AGENDA

City of Hapeville

Design Review Committee

May 15, 2019

LEFT ELEVATION

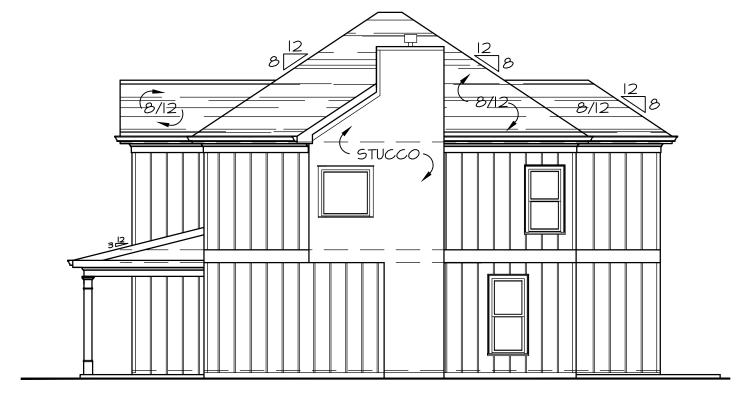
The first floor of the left elevation is windowless, which is inconsistent with the windows shown on the floor plans and is not permitted.

FRONT ELEVATION

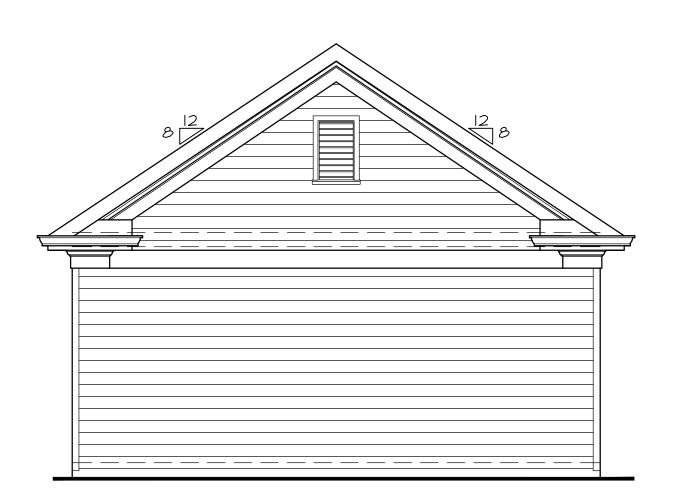
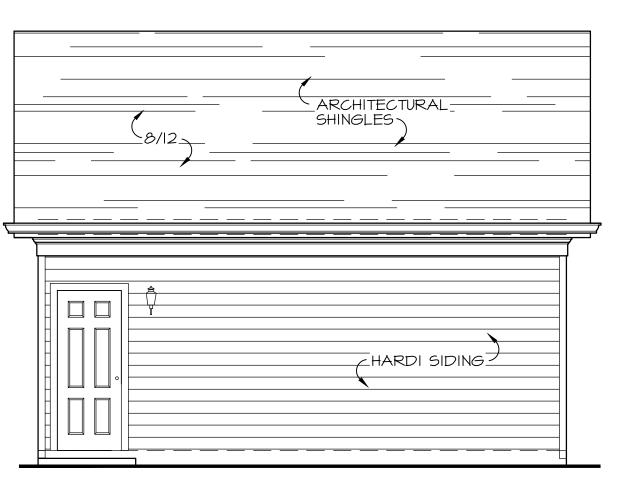
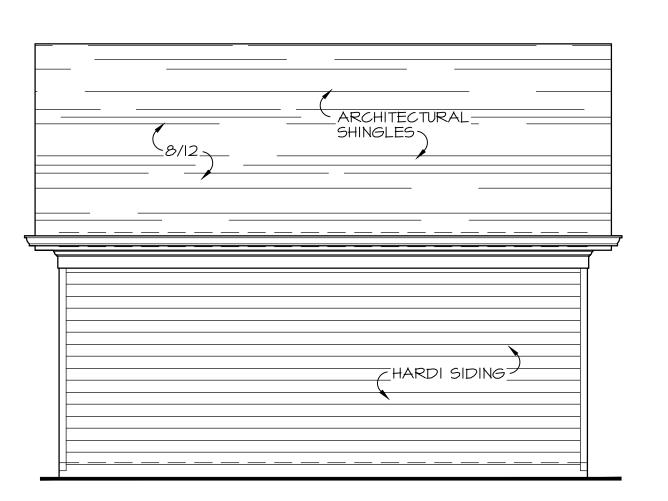
STAFF COMMENT: A light at the front door must be included in plans.

The Applicant should indicate the material of the gutters and downspouts and show downspouts on the plans.

STAFF COMMENT: Roofs must overhang beyond the facade by at least 12". The Applicant should indicate the distance the roof overhangs beyond

The first floor of the left elevation is windowless, which is inconsistent with the windows shown on the floor plans and is not

The Applicant should indicate the distance between the porch columns on the plans.

The Applicant should provide specifications for the windows, including size, recession from façade, trim, sill materials, and

STAFF COMMENT: presence of window lights.

STAFF COMMENT: The height of the first floor above grade is not provided in plans.

Window wall section dimensions are not provided in plans.

Site Plan

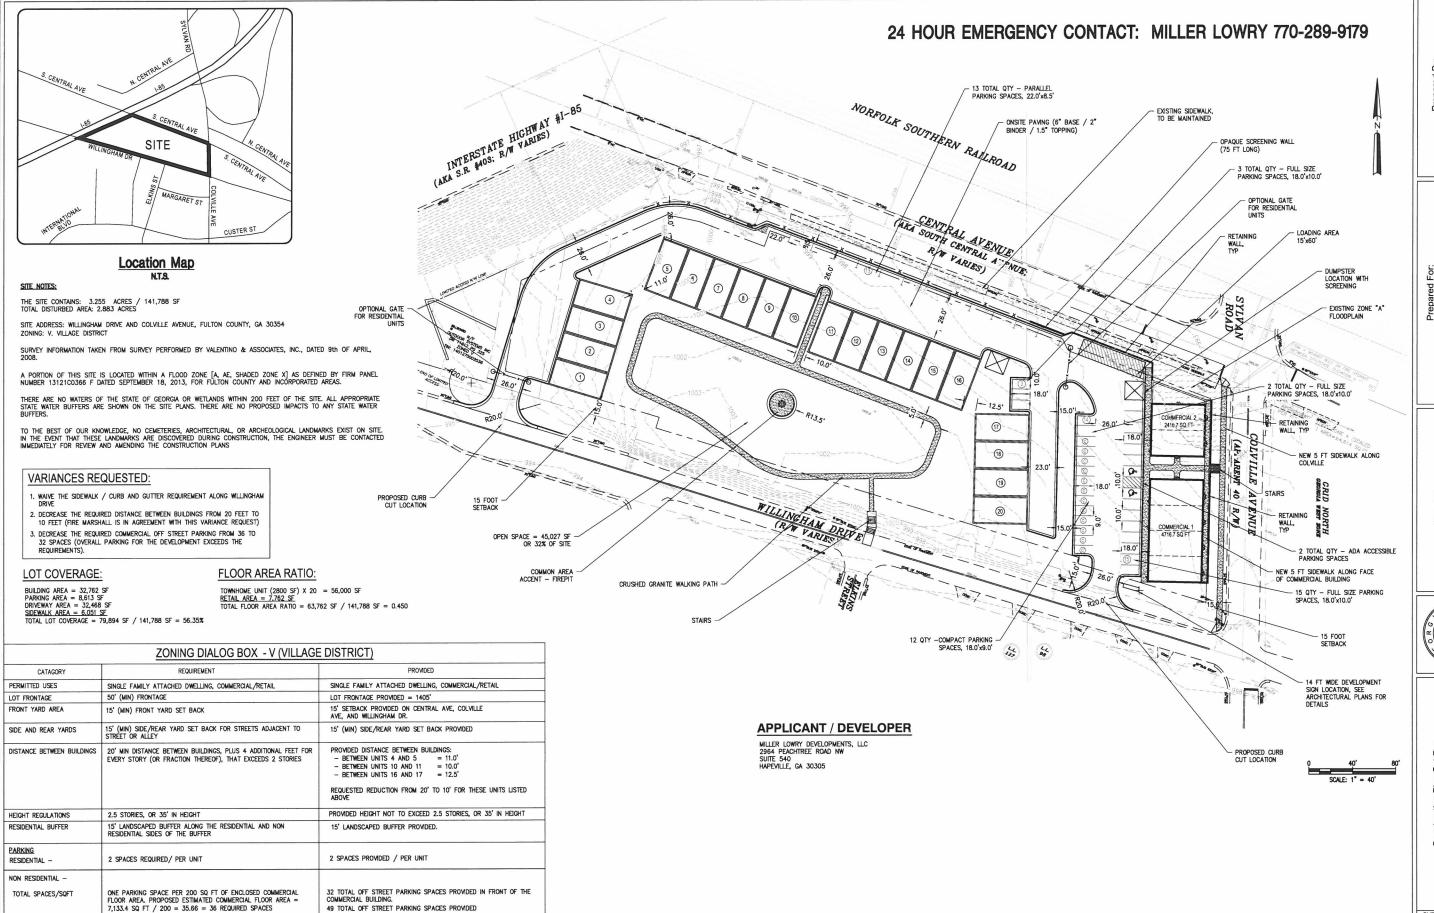
Sidewalks along South Central and Willingham must have a 6' clear area and a 5' landscape area. The dimensions for the existing sidewalk along South Central are not provided but must be brought to the required standards. No sidewalk is planned

The Applicant should specify the types of trees to be planted in the supplemental area.

Mechanical features are not shown on plans. Mechanical features must be screened from view. A light at the front door must be included in plans.

Warranty for the roof shingles not provided on plans. Roof shingles must have a usable life of at least 30 years. The Applicant should ensure roofs overhang a minimum of 12" beyond any facades.

STAFF COMMENT: The townhomes have identical, mirrored repeating facades and roof forms, which is not compliant.
